**ADDENDUM
(FINAL ENVIRONMENTAL IMPACT STATEMENT)**

**Management of Spent Nuclear Fuel
from the K Basins
at the Hanford Site,
Richland, Washington**

January 1996

**U.S. DEPARTMENT OF ENERGY
RICHLAND, WASHINGTON 99352**

Figure 3-11. Summary schedule for the foreign processing alternative (Bergsman et al. 1995)

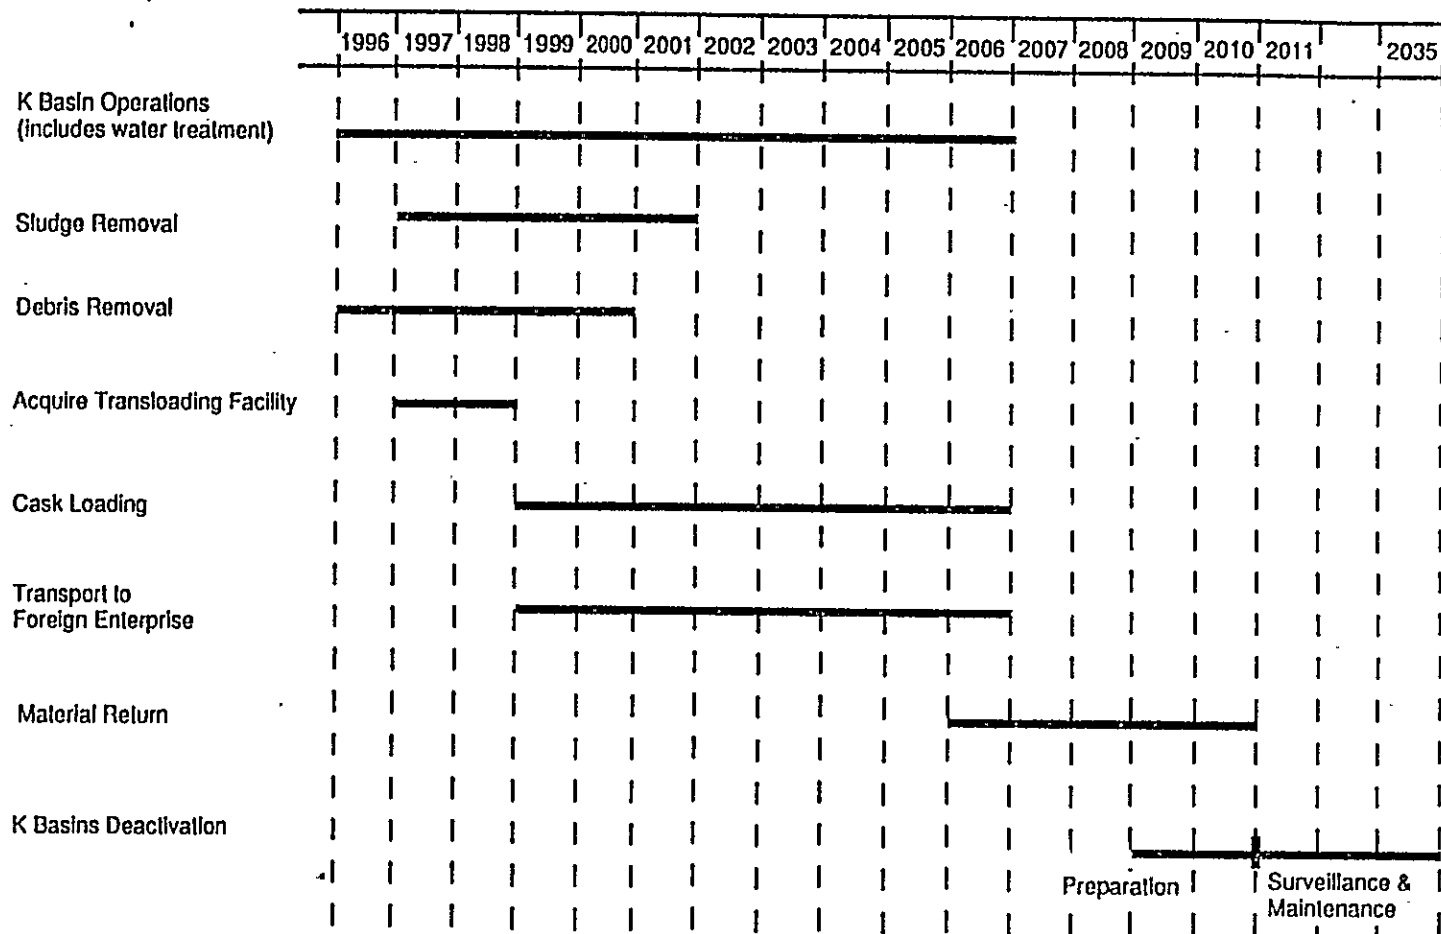
L09-C07. Pages 3.40 - 3.42 - "Packaging, Transport and Processing." The nine year period for shipment of fuel for foreign processing is excessive. There is no transport constraint which dictates this long a program. Seven years can be achieved easily, and given sufficient casks, the fuel can be transported as quickly as it can be removed from the basin (i.e., on the same timescale as any other option). The figure used for number of shipments

(4000) has to be a typographical error. BNFL's estimates assumed 600 shipments, on the basis that the shipments would be completed in 5-7 years (not the 9 years shown in Figure 3.11).

Page 3.40, first paragraph after bullet list, second sentence - change to read "The schedule in Figure 3-11 assumes maximum cask payloads and three shipments a year with 24 casks per shipment, for a total of 576 cask loads in 24 shipments to remove all the SNF from the K Basins."

Page 3.41, Figure 3-11 - replace with corrected Figure 3-11.

Figure A-9. Proposed calcination facility (Bergsman et al. 1995)

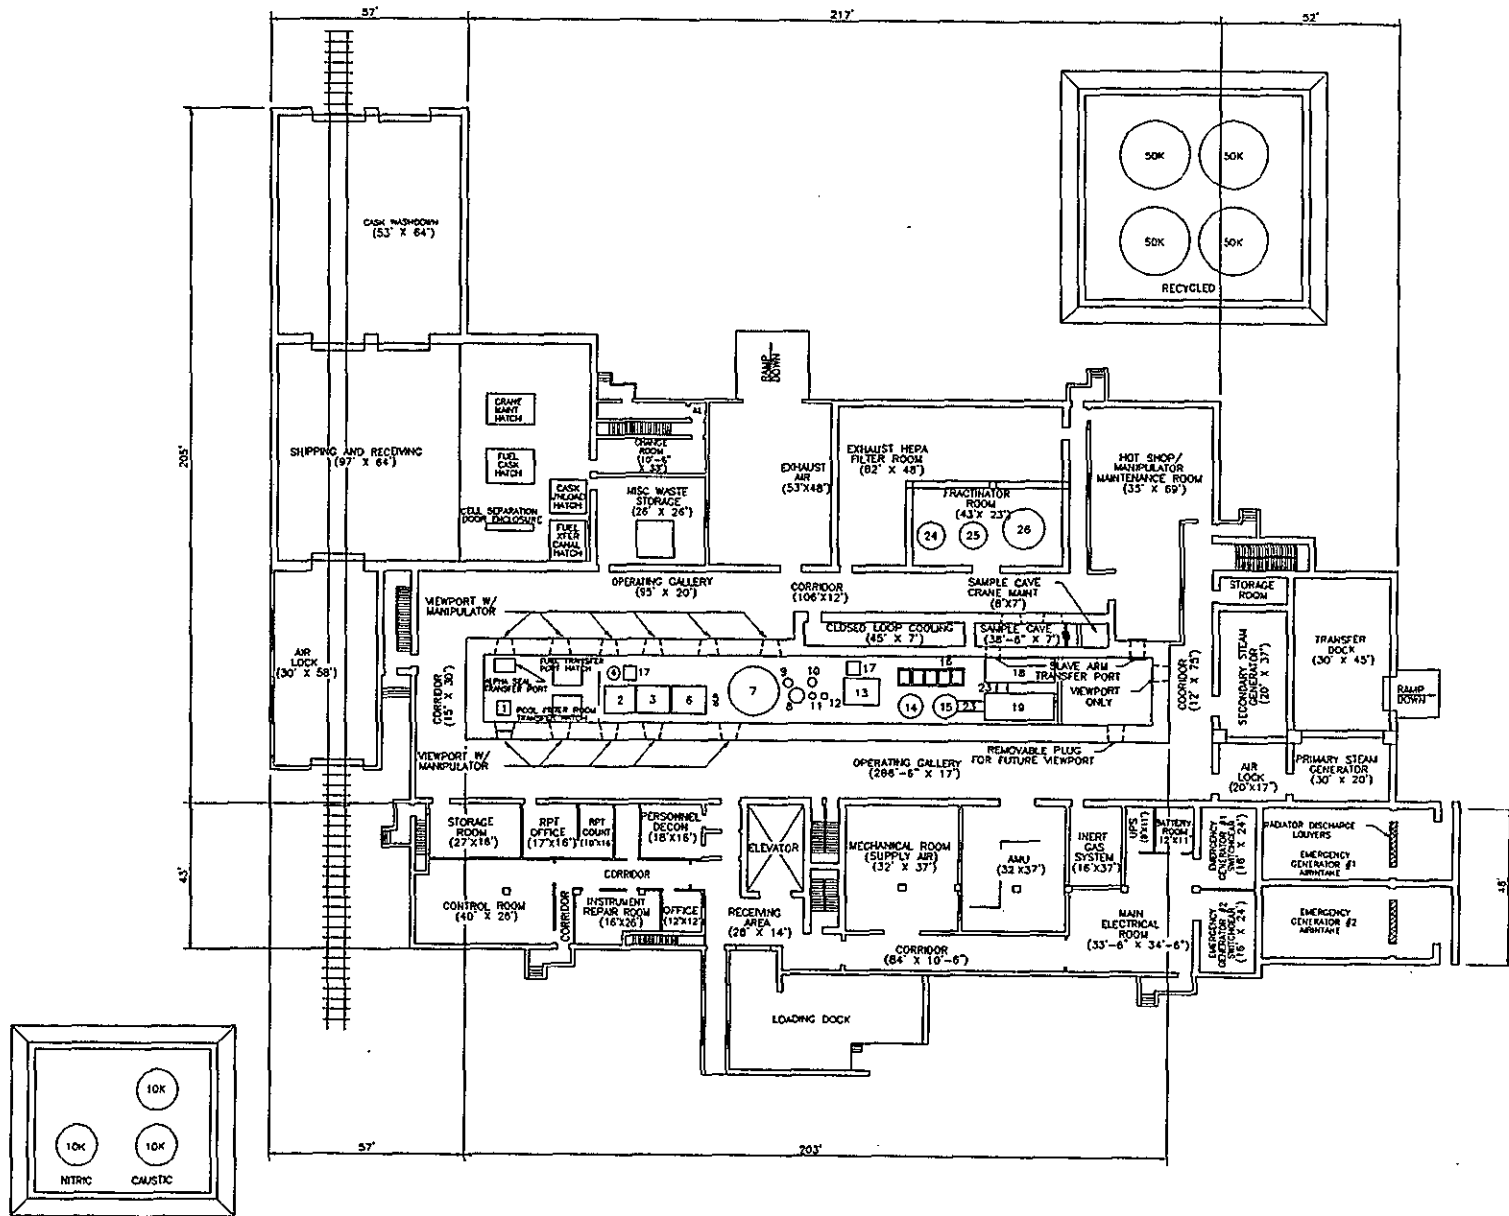
L05-C22. Page A.21, Fig. A-9. Locations within Figure A-9 are numbered; however, the numbers are not explained in a legend. For purposes of understanding, it is helpful to have a legend.

R. Figure A-9 is incorrectly labeled. The correct Figure A-9 is provided in the Errata section of this Addendum. These figures were intended to indicate the scope and complexity of the facilities, not to provide details of the design.

Page A.21, Figure A-9 - replace with correct Figure A-9, attached.

Figure A-11. Proposed onsite processing facility

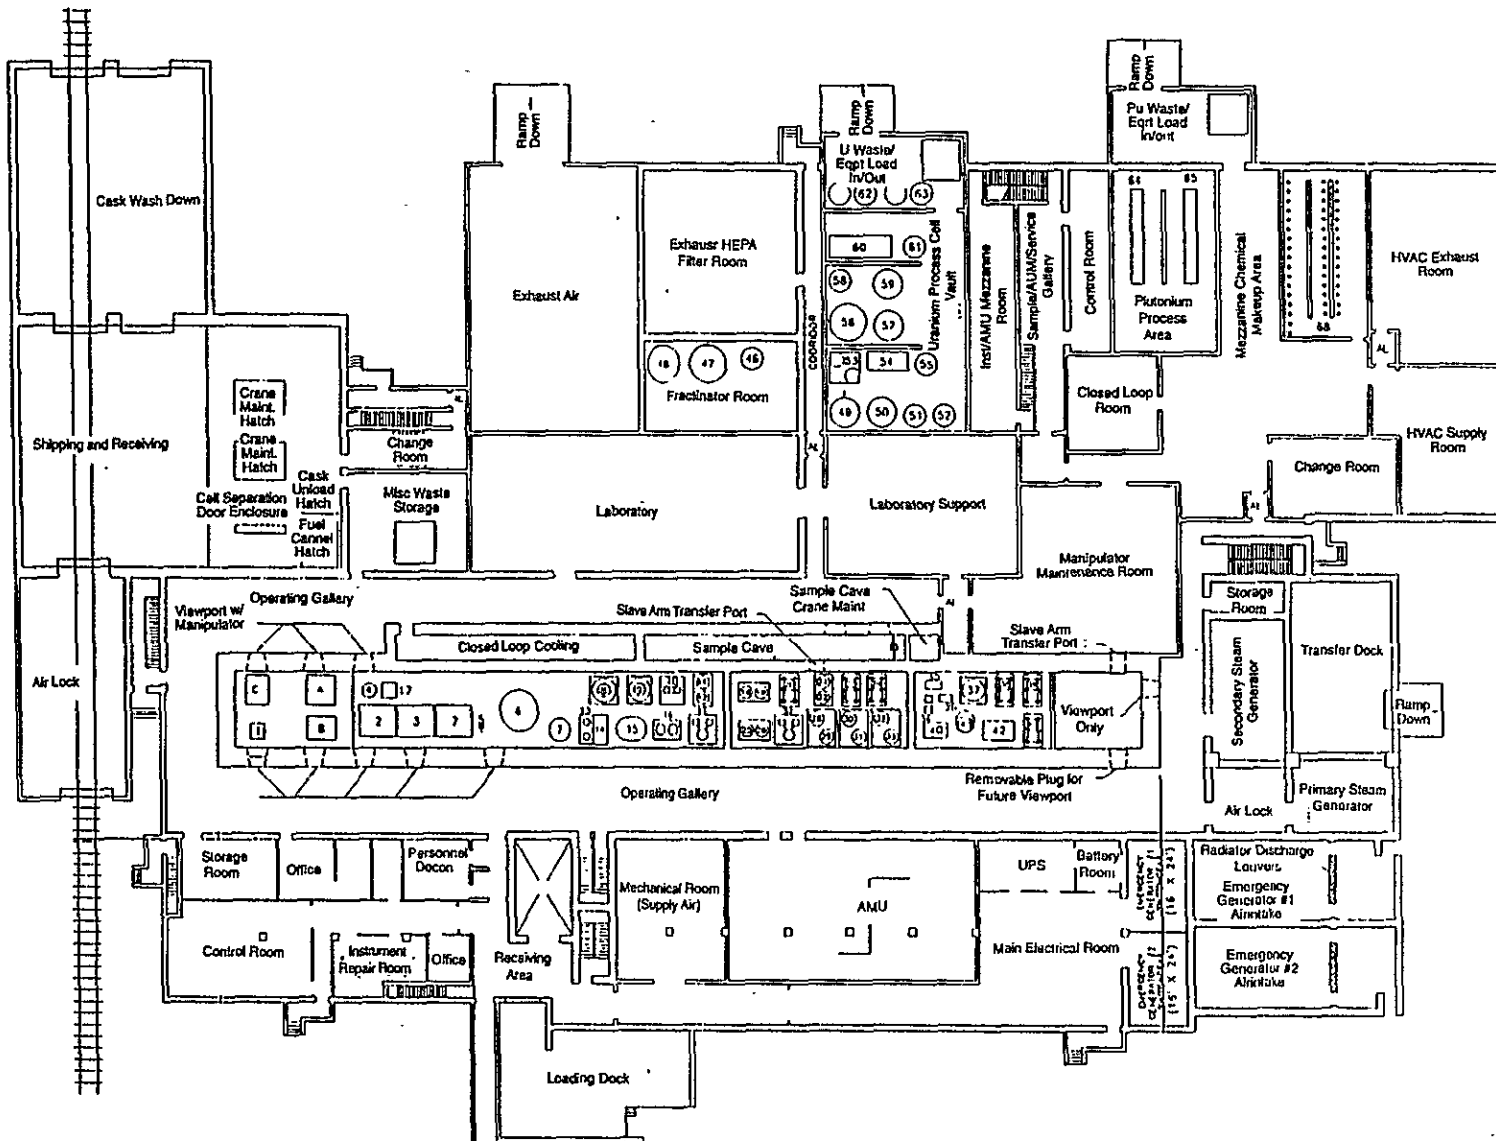
L05-C23. Page A.24, Fig. A-11. We would like to know the locations of positions 24, 26, and 27 not shown on the figure. Also, what is the purpose of a cold trap as shown at position 12? Information like this is important in evaluation of K-Basin alternatives.

R. Item 24 is below the elevation of the figure. It extends to the north from item 3 to item 2. Items 26 and 27 are on the second floor of the building above the elevation of the figure. Item 26 is above item 7. Item 27 is nominally above items 4 and 22. The cold trap is to condense gases released during SNF processing. This figure was incorrectly labeled in the Draft EIS; it actually depicts the proposed conditioning facility. The correct figures are provided in the Errata section of this Addendum.

Page A.24, Figure A-11 - replace with correct Figure A-11, attached.
